# UNITED STATES PATENT AND TRADEMARK OFFICE

10/829,275

<b>Office Action Summary</b>	<b>Application No.</b> 10/829,275	<b>Applicant(s)</b> SUZUKI ET AL.	
	<b>Examiner</b> MARK R. WENDELL	<b>Art Unit</b> 3635

## DETAILED ACTION

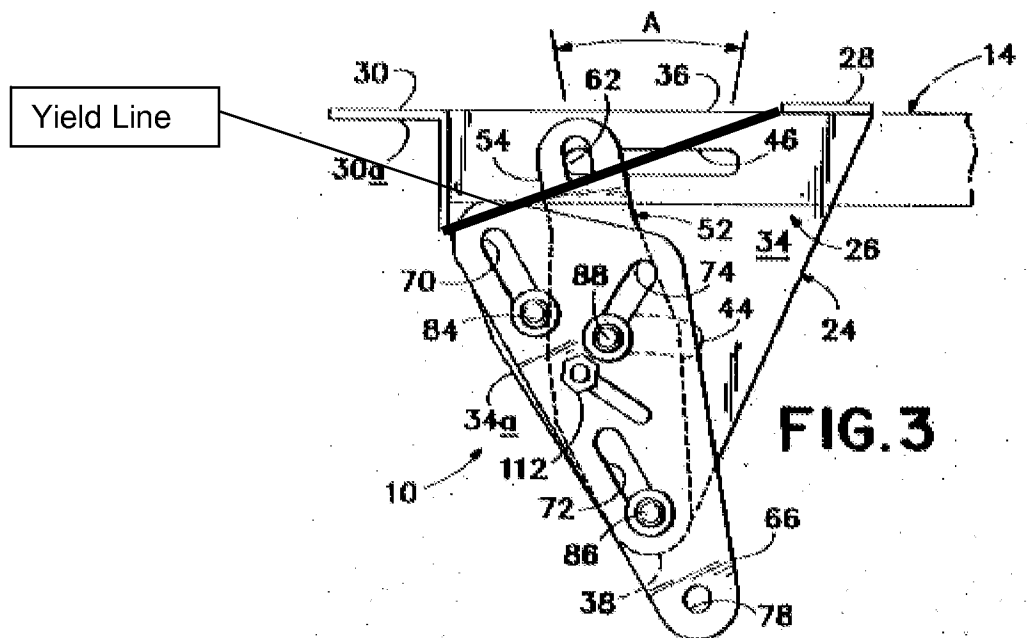
Regarding claims 8 and 20, Reetz illustrates in Figure 2 the gusset plate (34) including a first joining plate (30) connected to a first edge thereof and a second joining plate (28) connected to a second edge thereof, and at least one of said plurality of splice plates (52) extends toward a corner of the gusset plate (See Figures 3 and 4) beyond a yield line of the gusset plate to increase the buckling strength of the gusset plate, said yield

line being formed by a diagonal line extending from an edge of the first joining plate to an edge of the second joining plate.

Regarding claims 10-11 and 22-23, Reetz illustrates in Figure 2 reinforcing ribs (108 and 109) on the structural member (104). When assembled (see Figure 1), the reinforcing ribs are connected to the gusset plate (34) via the structural member (104) and do not cross the yield line (as shown in the Figure above). Reinforcing rib 109 stays above the yield line while one of the reinforcing ribs 108 stays below the yield line.

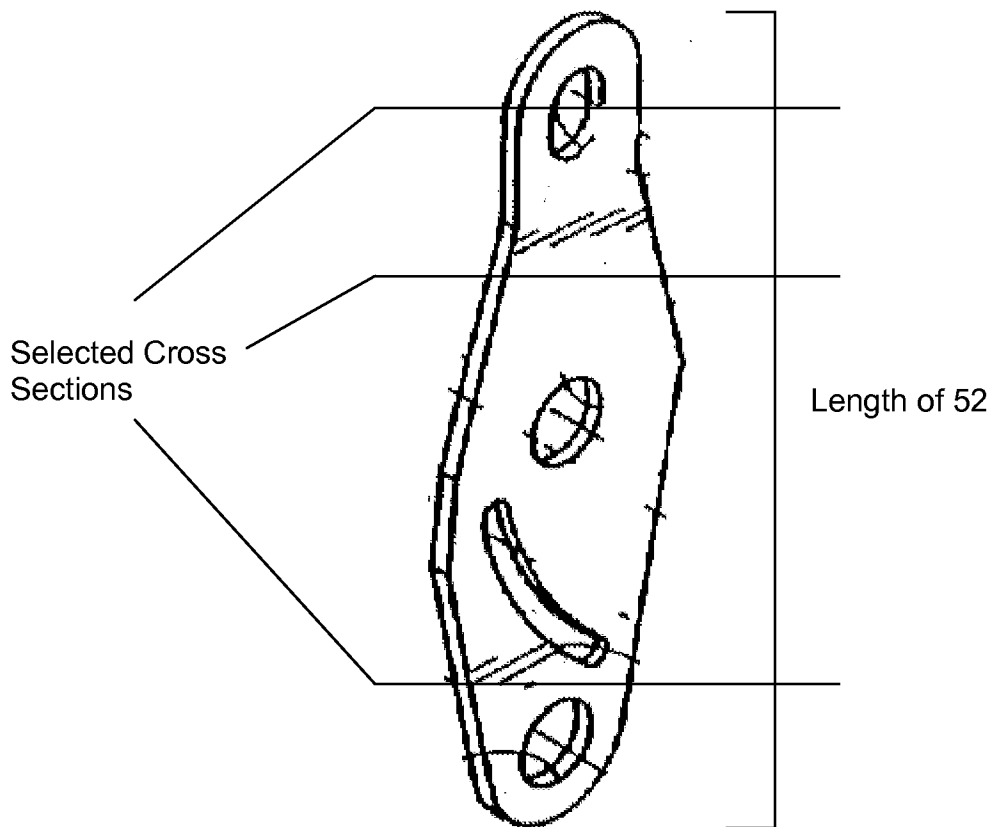
The examiner is perplexed with regard to this argument. The following illustration hopefully will clarify the examiner's position:

The examiner notes that the cross-sections in this instance are not rectangular.

Rectangular is by definition four sided, with right angles formed at the intersection of each side. This is certainly not the case with these selected cross sections. The

examiner notes that the object is slightly tilted within the Figure, however the inherent shape of the plate is not rectangular and thus would lend to non-rectangular cross-sectional lengths. The examiner further notes that if thickness is meant by the applicant, the claim language should be re-worded to address that limitation. As the claim language stands, the limitation can be read broader than this intended limitation.
